Access Compliance Report Public Rights-of-Way (Curb Ramps)

Intersection ID: N/A Main Street: BYRUM_DR Cross Street: COOLEMEE_DR Location: SE

ADA ID: A9F848AC4378 Ramp Type: Perp Initial Pass/Fail: Fail Overall Compliance: No Severity Score: 1.25

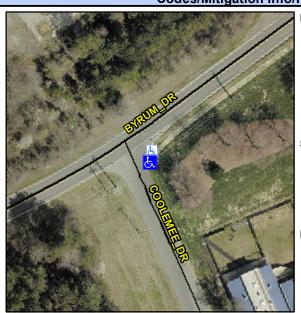
Field Measurements/Component Compliance					
Compliance Description		Data	Comp	oliance Description	Data
N/A	Ramp Length (in)	53.0	Yes	Ramp Slope (%)	7.9
Yes	Ramp Width (in)	48.0	No	Ramp XSlope (%)	3.5
N/A	Flare Type LT	N/A	N/A	Flare Type RT	N/A
N/A	Flare Slope LT (%)	N/A	N/A	Flare Slope RT (%)	N/A
N/A	Flare Traversable LT?	N/A	N/A	Flare Traversable RT?	N/A
N/A	Landing Length (in)	N/A	N/A	DWS Provided?	N/A
N/A	Landing Width (in)	N/A	N/A	DWS Contrast?	N/A
N/A	Landing Slope (%)	N/A	N/A	DWS Length (in)	N/A
N/A	Landing X Slope (%)	N/A	N/A	DWS Full Width?	N/A
N/A	Landing Curb? (Y/N)	N/A	N/A	DWS Offset (in)	N/A
N/A	Shared Landing?	N/A			
N/A	Gutter Ponding?	N/A	N/A	Gutter Slope (%)	N/A
N/A	Gutter Lip Ht (in)	N/A	N/A	Gutter X Slope (%)	N/A
N/A	Painted X Walk1?	No	N/A	Painted X Walk2?	N/A
	X Walk 1 Direction	To W		X Walk 2 Direction	N/A
N/A	X Walk 1 Width (in)	N/A	N/A	X Walk 2 Width (in)	N/A
	X Walk 1 Slope (%)	2.5		X Walk 2 Slope (%)	N/A
